Giant Mine Environmental Assessment

Round One: Information Request - Yellowknives Dene First Nation #09

INFORMATION REQUEST RESPONSE

Information Request No: YKDFN #09

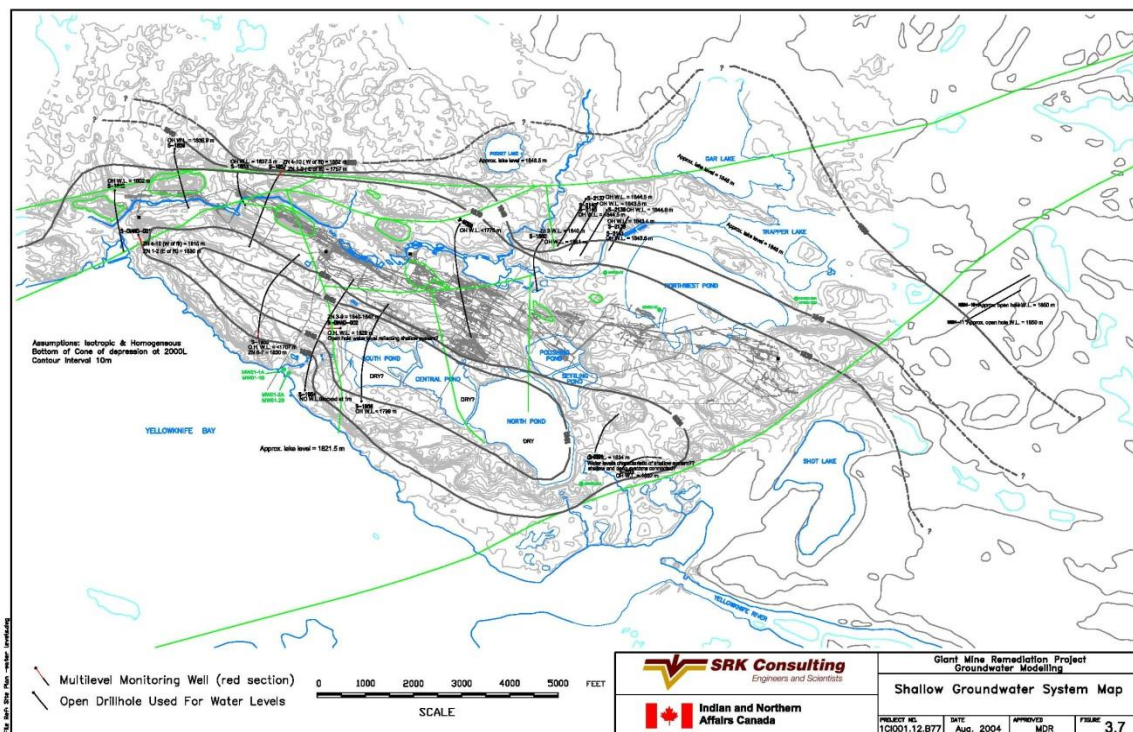
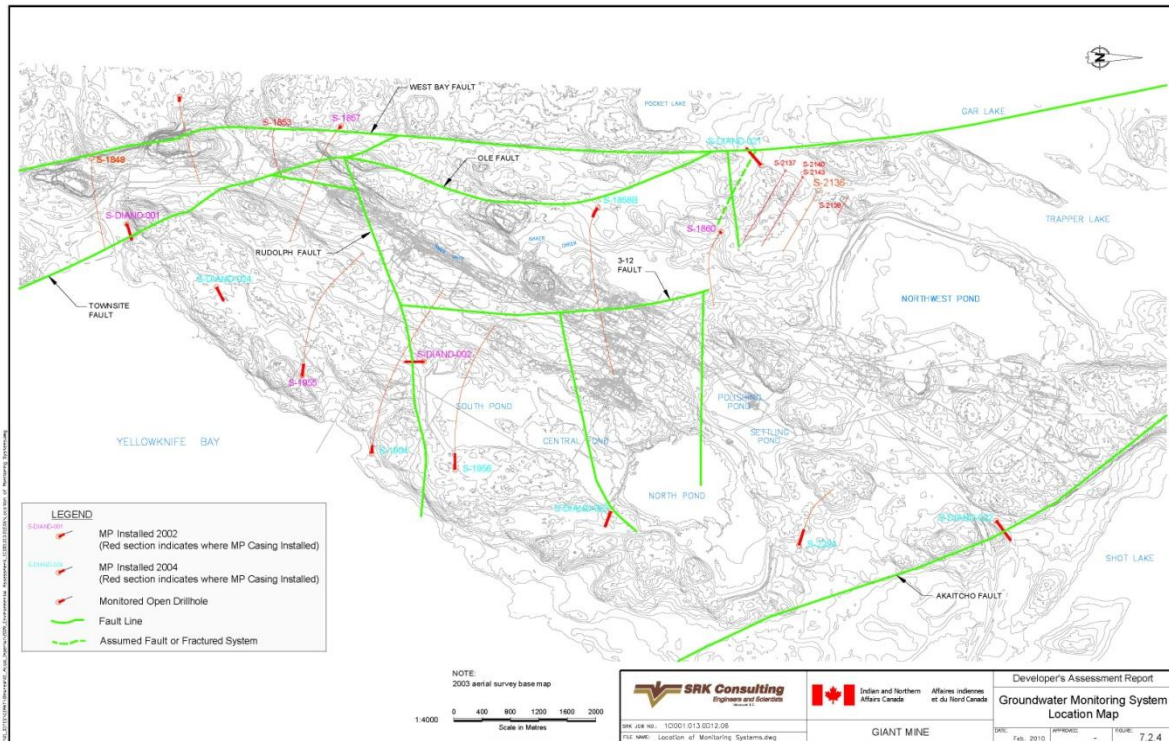
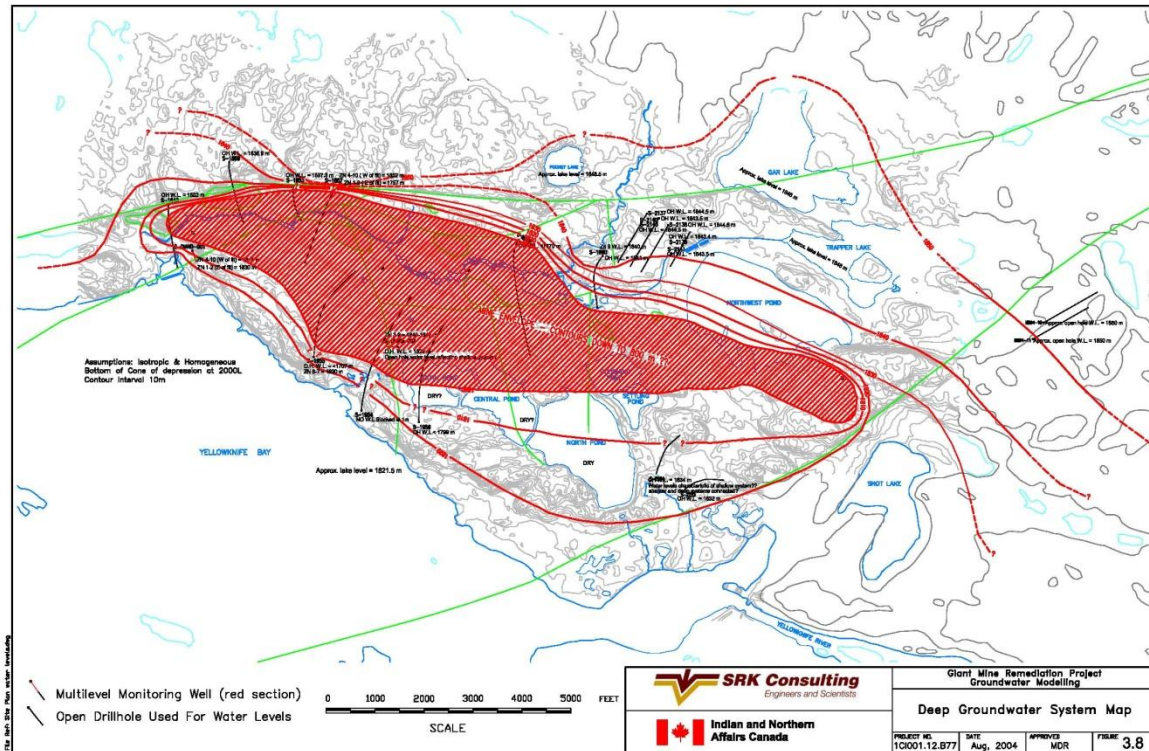
It is requested that the proponent outline how the groundwater monitoring data (piezometric level and geochemistry) will be used to evaluate the hydraulic capture zone and its ability to maintain an inward hydraulic gradient into the underground mine workings. As part of describing the evaluation of the hydraulic capture system it is requested that the proponent identify threshold values for piezometric water levels and geochemistry, and detail corresponding contingency activities if the hydraulic system is deemed to be not working efficiently.

The monitoring system layout is presented in Figure 7.2.4 of the DAR. Groundwater levels have been monitored in the fifteen deep multilevel monitoring well systems, comprising 129 separate monitoring zones in total, every year during re-flooding. Water levels measured using the monitoring systems were first presented in the groundwater monitoring report (SRK, 2005) in Figures 3.7 and 3.8, as presented below.

Biannual monitoring has shown that piezometric levels have not reacted significantly to the re-flooding of the mine from the fully dewatered condition (approximately 600m below ground surface) to the current partially dewater condition (approximately 230m below ground surface). Therefore, the water contours in figures below are still representative of current conditions at the site and support the presence of a hydraulic trap surrounding the partially dewatered mine.
